*Bridge Preliminary Design Report  
Addendum*

**Ramp B over Norfolk Southern Tracks  
SCI-823-1598**

**SCI-823-10.13  
PID No. 79977**

Prepared for  
**Ohio Department of Transportation**

**Figure 1: - Bridge vs MSE Wall Cost Comparison**

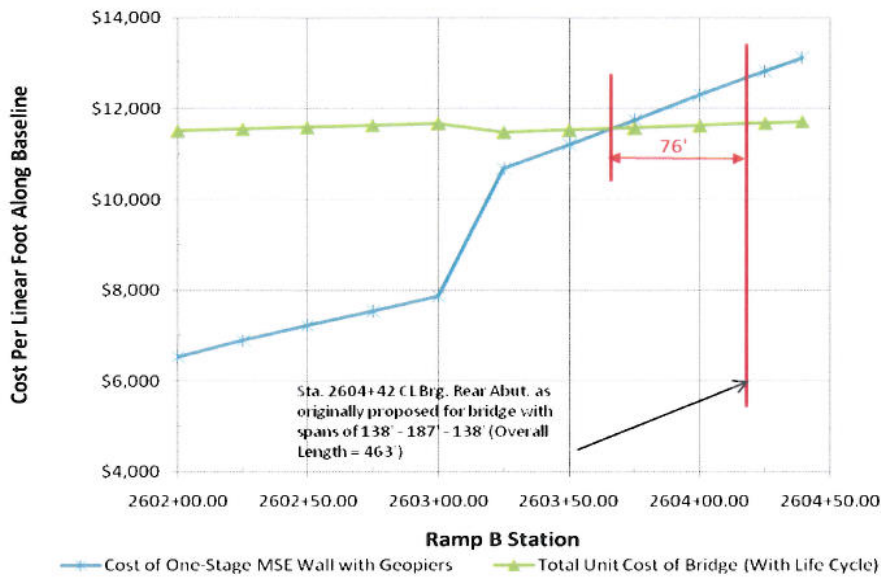
Total bridge and wall costs were then converted to a unit cost per foot of bridge and unit cost per foot of wall and were plotted in Figure 1. The wall and bridge unit costs intersect at a point  $\pm 76$  feet from the originally proposed location of the rear abutment. This would indicate that it may be economical to lengthen the bridge and reduce the length and height

of MSE Wall 4.

**Figure 2: Bridge Costs for Various Length Bridges**

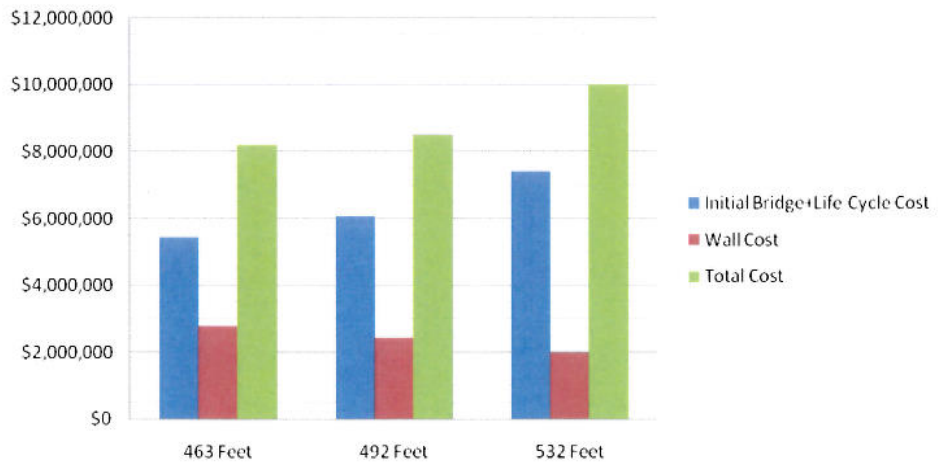
Figure 2 shows that as the bridge length increases the wall costs decrease, however the bridge costs are increasing at a faster rate than the wall costs. This results in the 463 foot long bridge, as proposed in the November 2007 report, as being the lowest cost solution.

**RAILROAD MINIMUM CLEARANCE REQUIREMENTS**

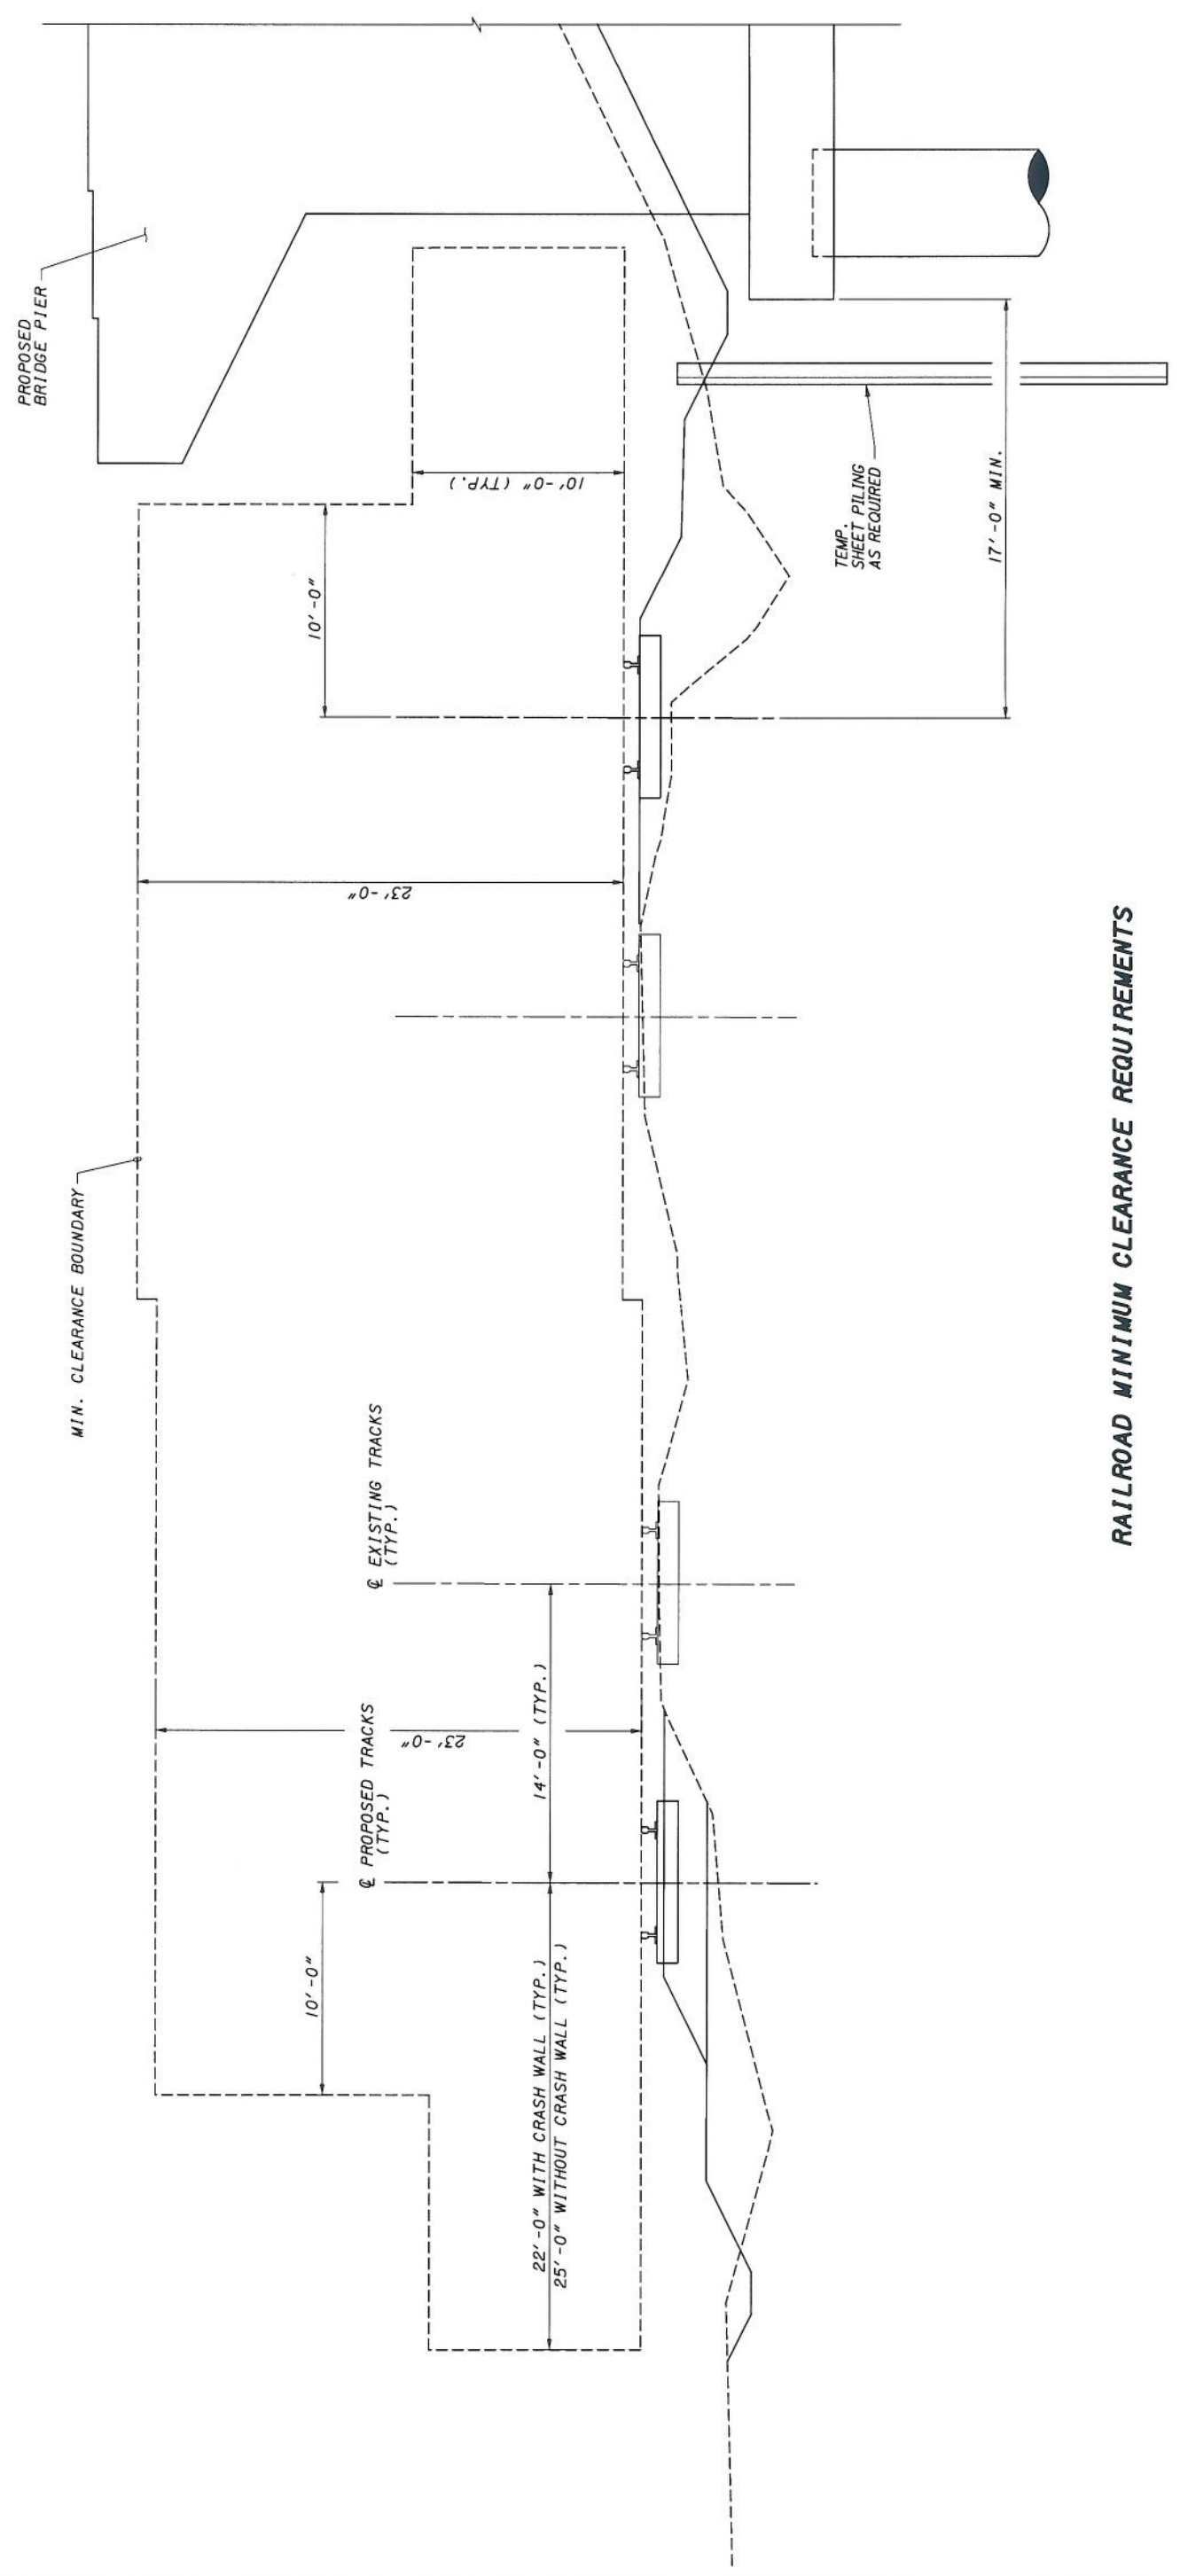
As discussed, your interpretation is somewhat confused. The T portion of the cap can not be any closer to the track than 10'-0" if bottom portion is less than 23'-0" above top of rail.

Good afternoon. I hope you are doing well. Attached is a .pdf drawing showing our interpretation of your criteria for clearances at the US-23/SR-823 Interchange, as we understand them. Both Norfolk Southern and ODOT have clearance requirements. We will use the most conservative requirement, in the event of conflicts or differences between the two agencies.

One thing of note is the location of the T-type pier. Our understanding is that as long as the pier stem is a minimum of 22'-0" from the centerline of the track and 10'-0" high, the pier cap can extend inside of the 22'-0" clearance envelope. Again, due to the two new tracks and the curvature of the ramps, our goal is to shorten the span lengths as much as possible.
